From: Hilary Saunders
Sent: 11 May 2016 09:46
To: Planning
Subject: FW: Coach Road Development, Sleights by Gray and Sons.
Attachments: D10612-22G.pdf; D10612-23B.pdf; D10612-24A.pdf; D10612-17B.pdf

From: Tim Harrison (BHD)
Sent: 11 May 2016 09:18
To: Hilary Saunders
Subject: Coach Road Development, Sleights by Gray and Sons.

PROJECT:
Land to West of Coach Road, Sleights

Proposed sections through lettered points on proposed adoptable road

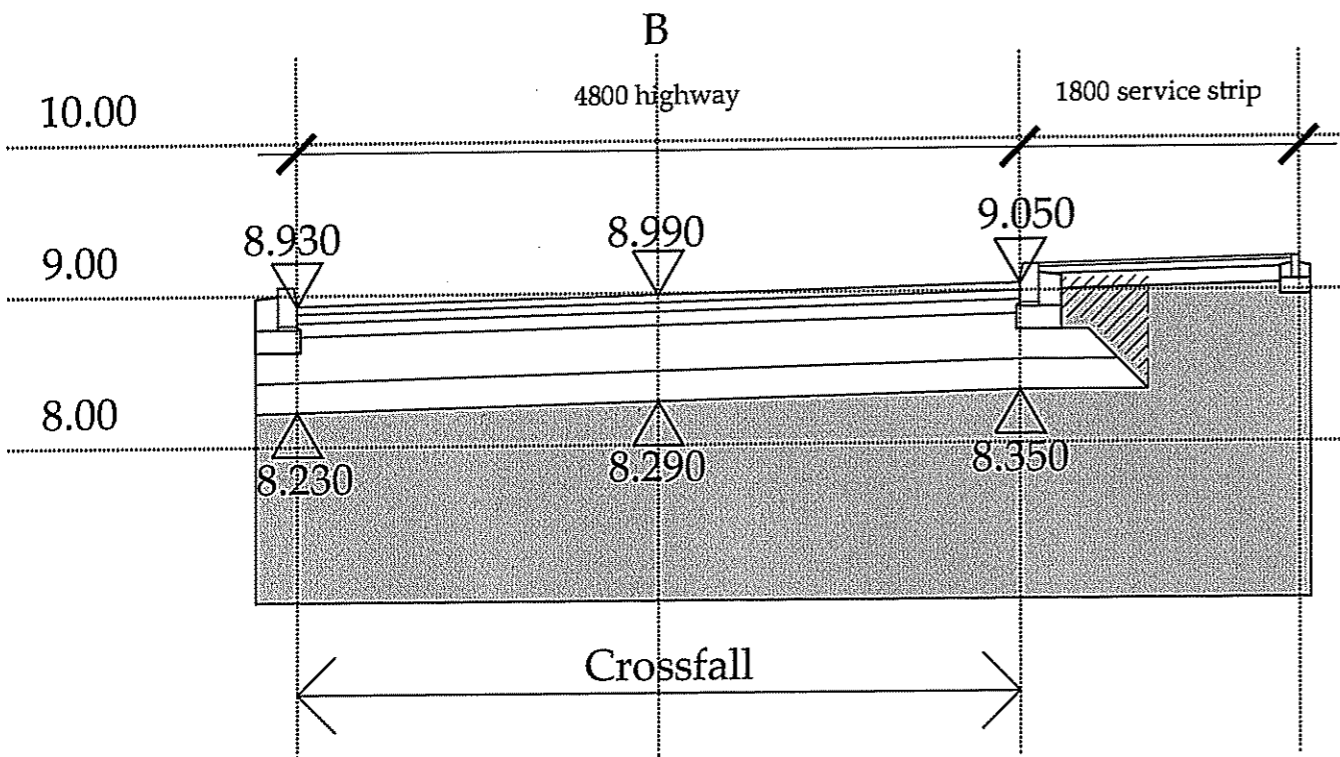
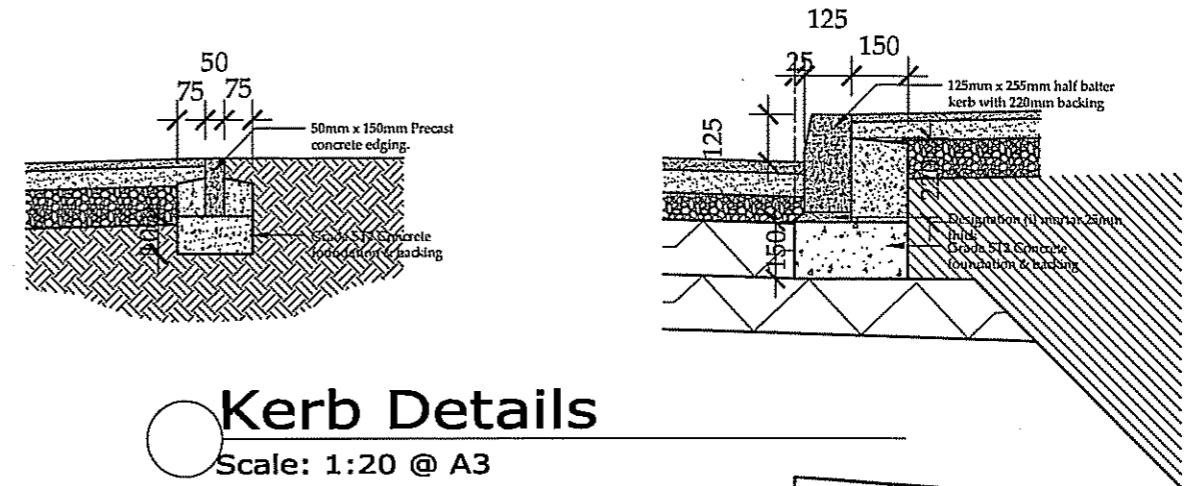
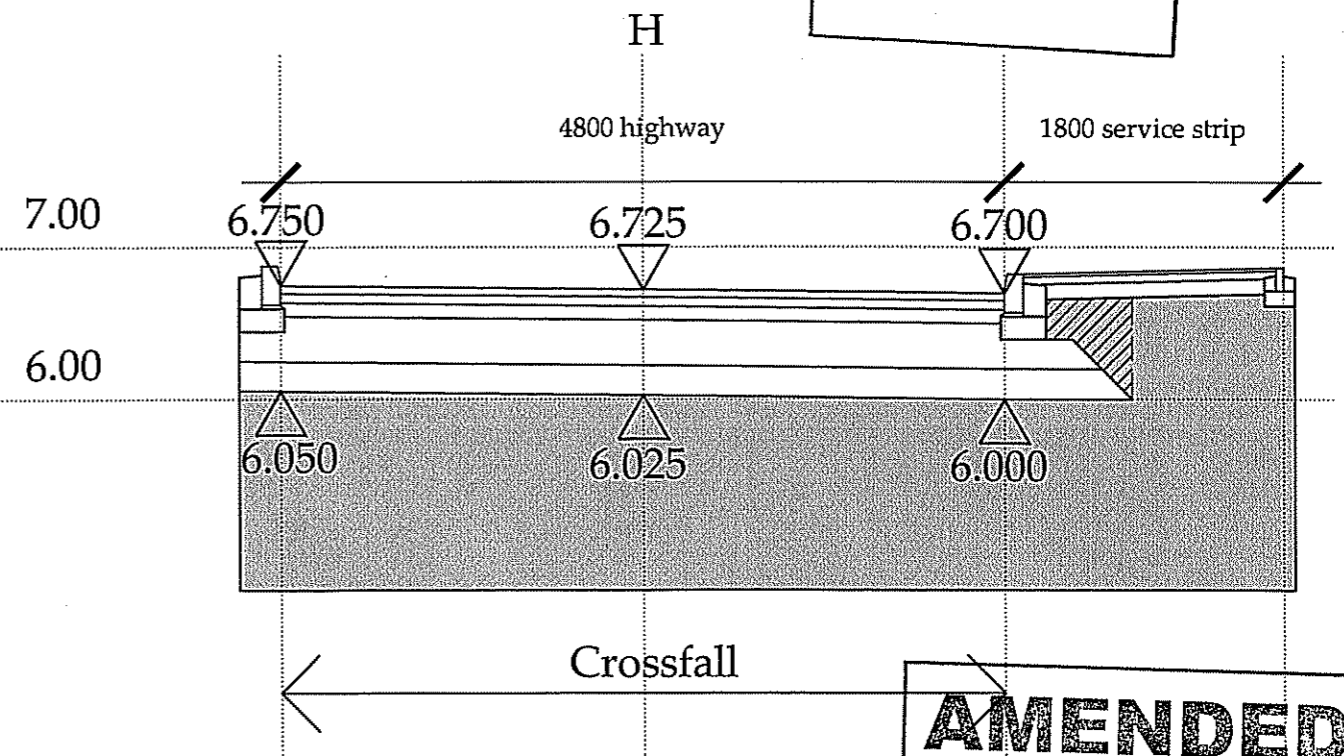
REV	DATE	BY	AMENDMENT	CHKD	APVD
B	10.05.16	CW	Amended to suit NYCC		
A	19.01.16	CW	Issued for approval	TRH

Proposed Plans & Elevations
 For New Detached House

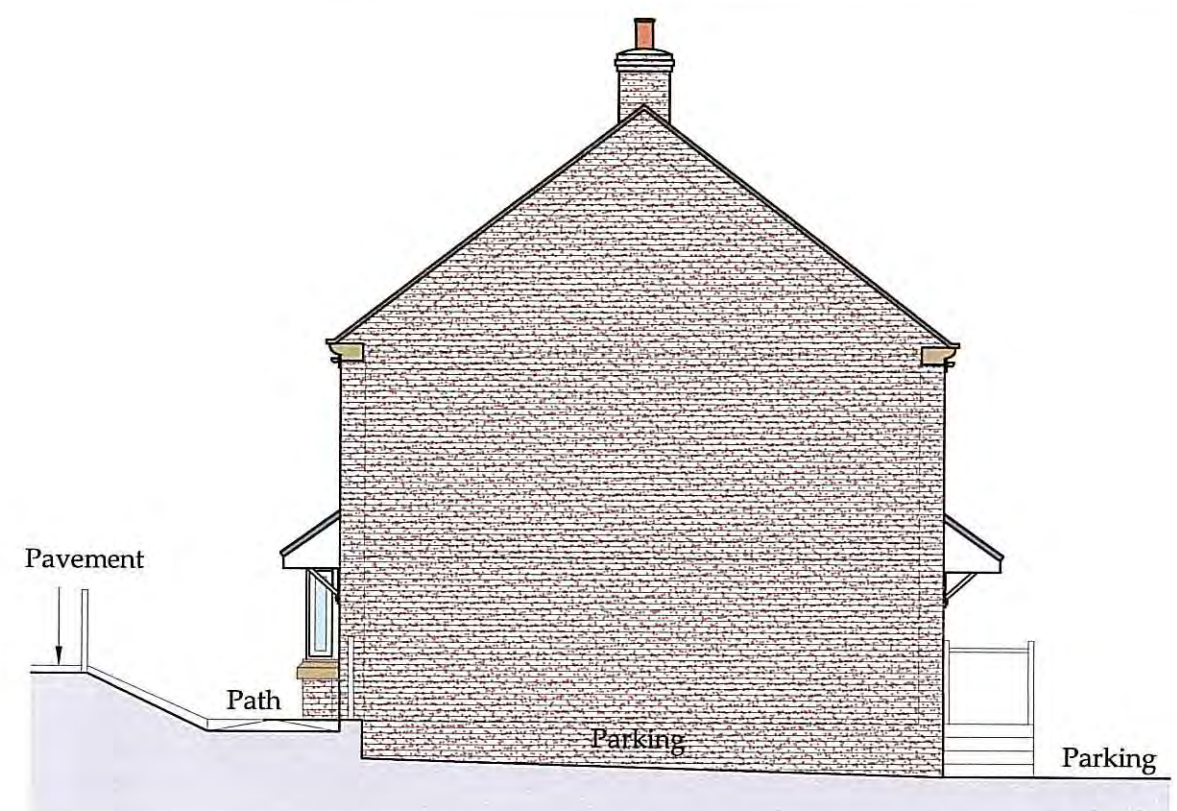
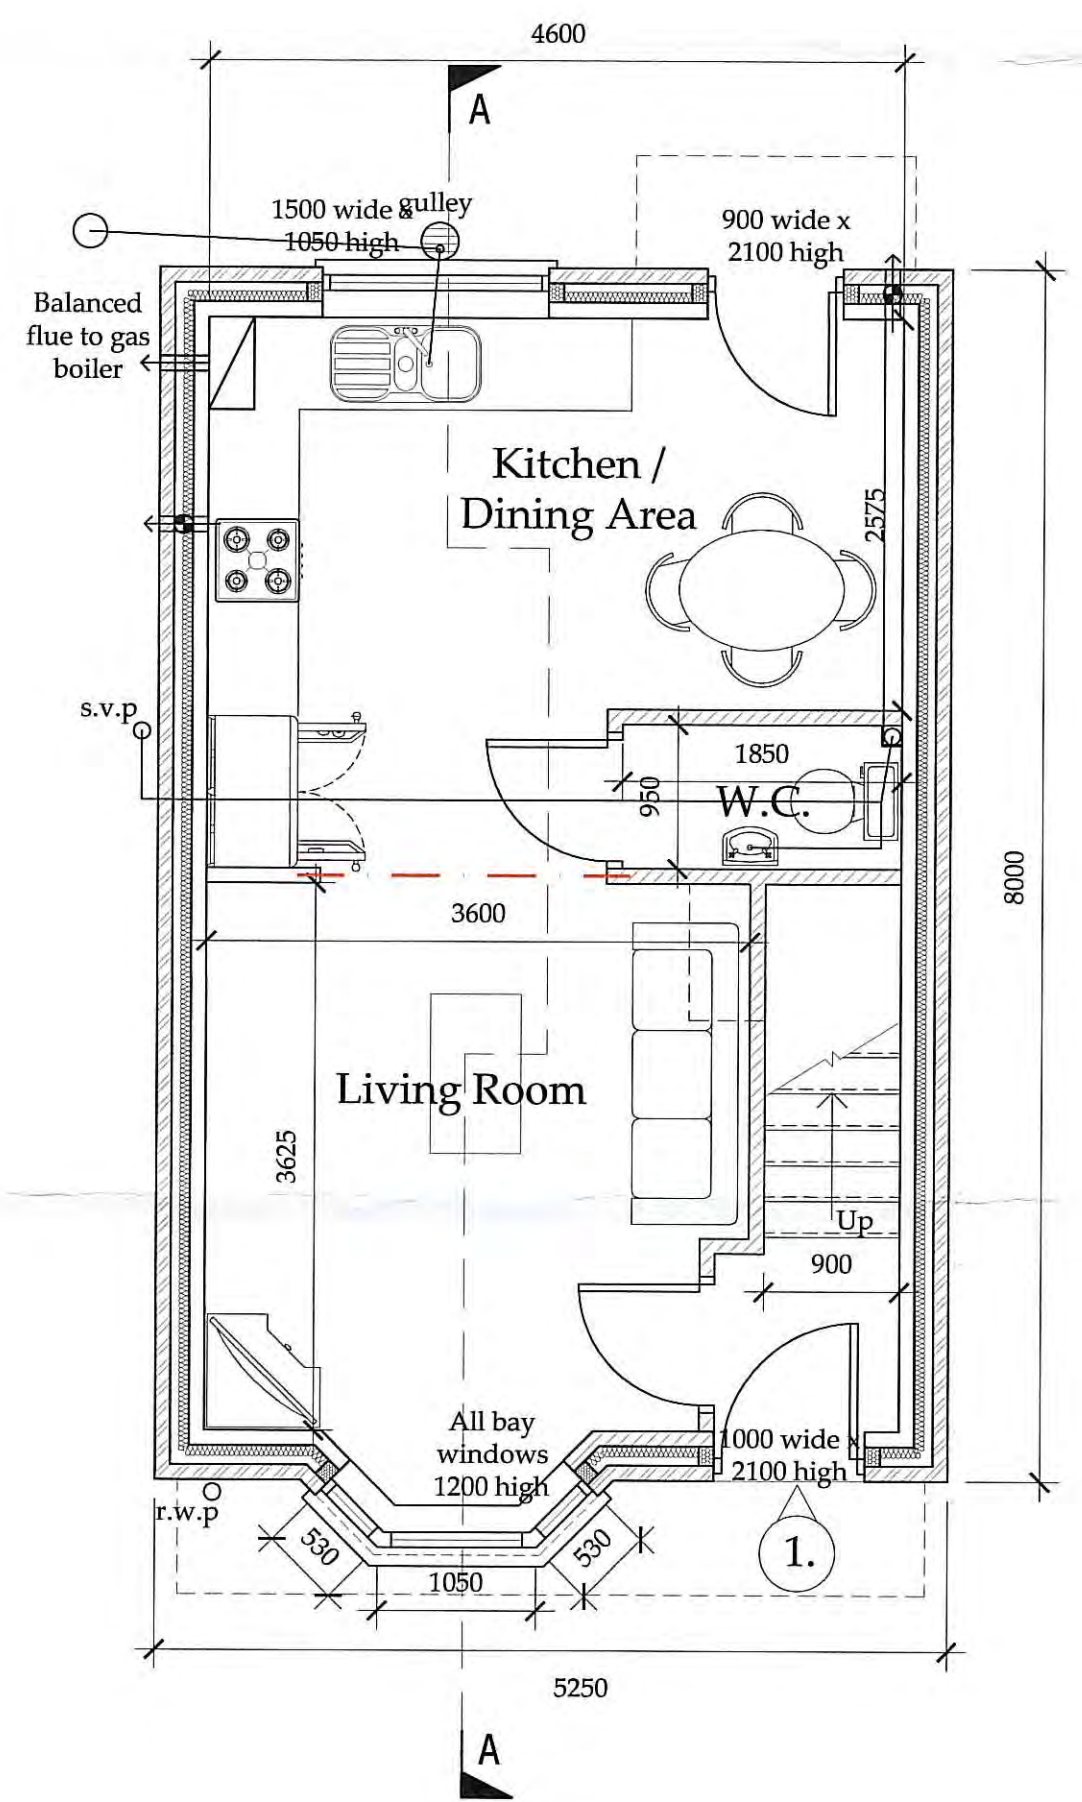
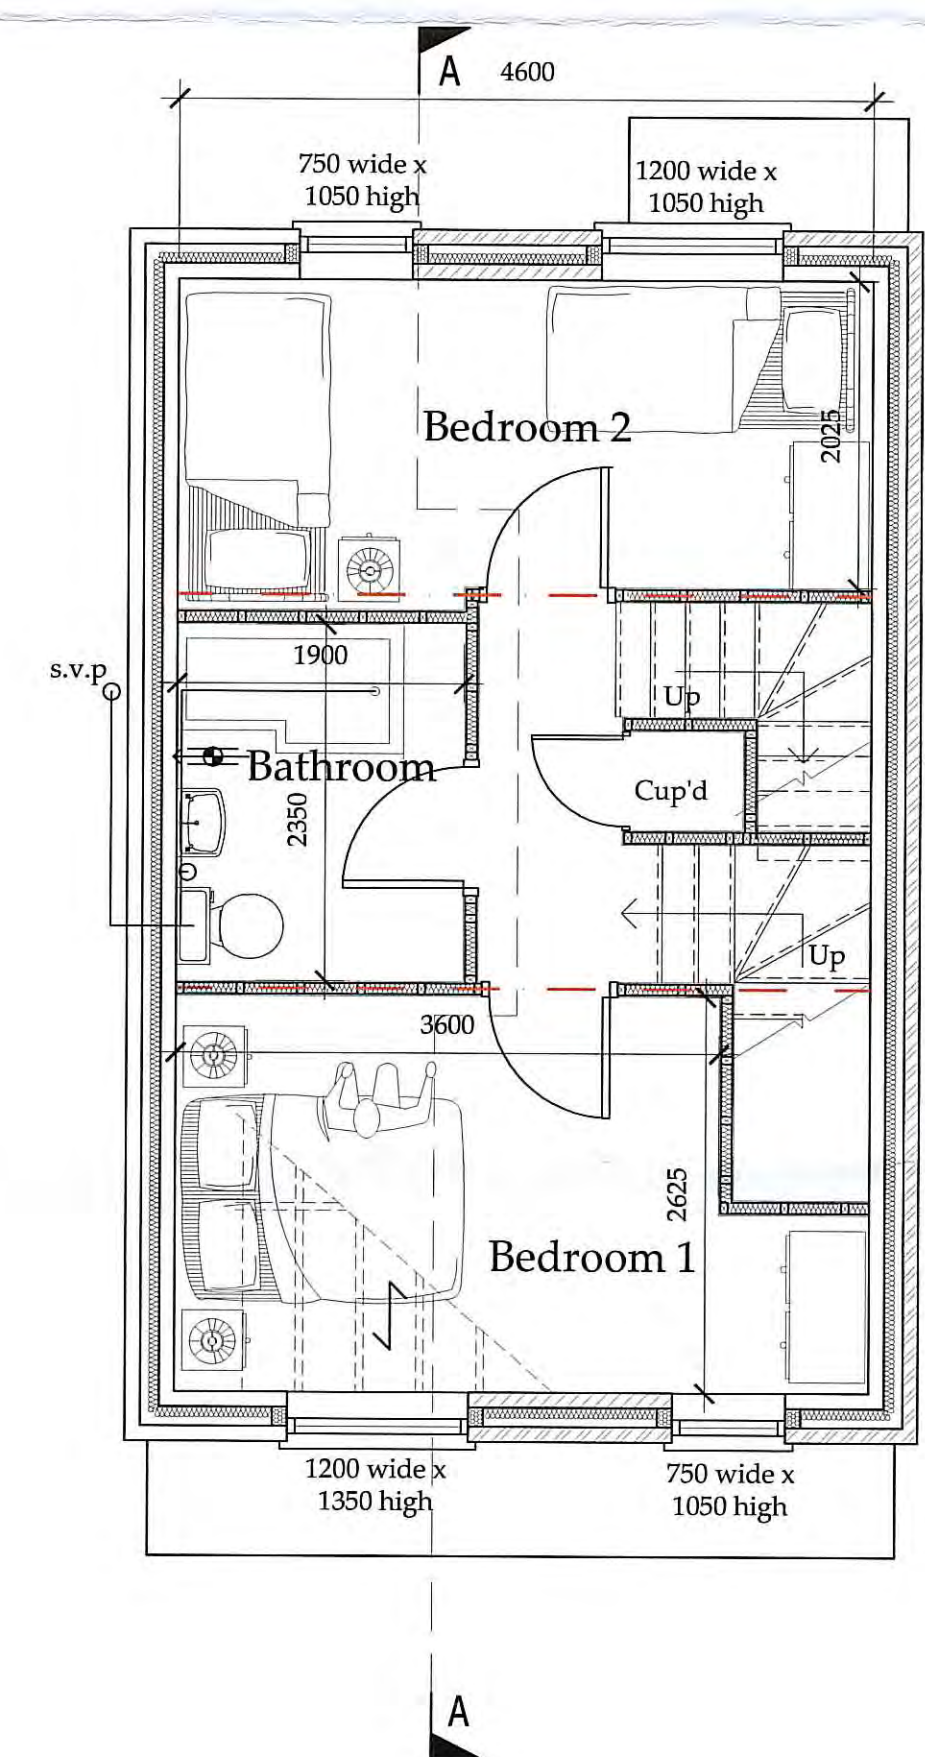
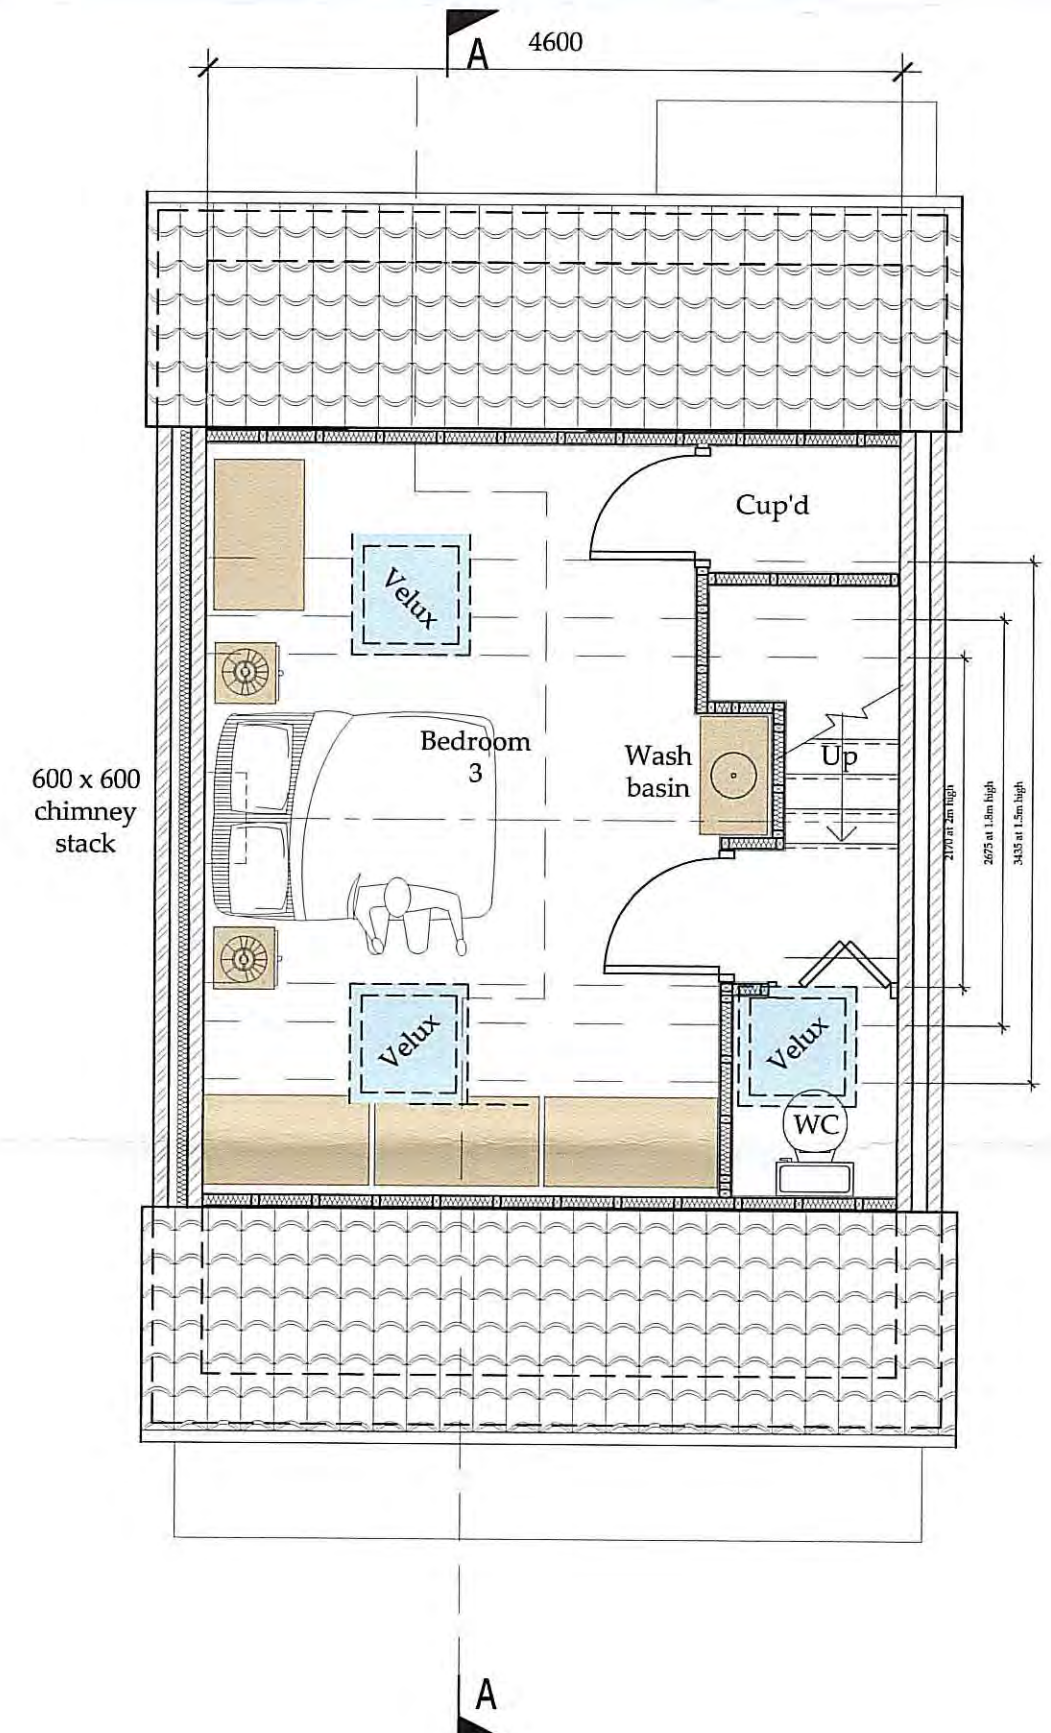
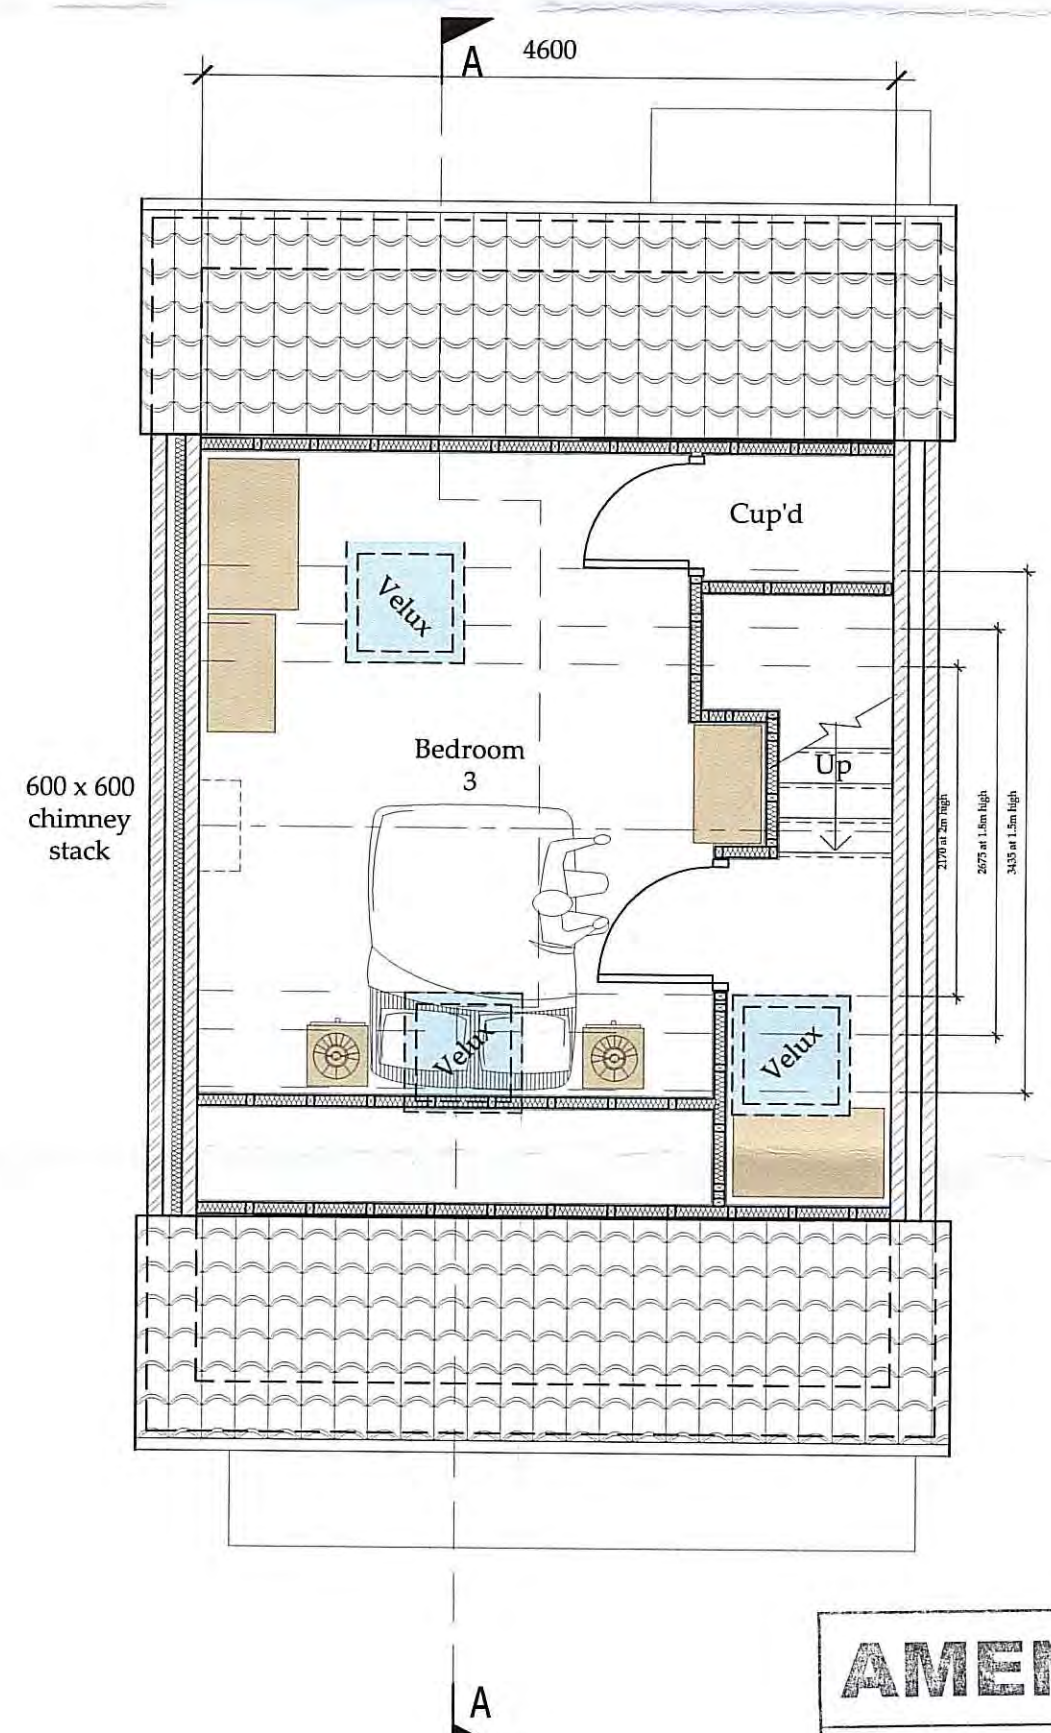
With regard to the above development and your request for a revised drawing to show the detached house at the entrance to the site we provided Colin Gray with copies of this drawing last week and we know that he prefers to have a paper copy for himself and to deliver or post a paper copy to you.

B	06.05.16	CW	Amended to suit client
A	23.12.15	CW	Issue for approval
REV	DATE	BY	AMENDMENT
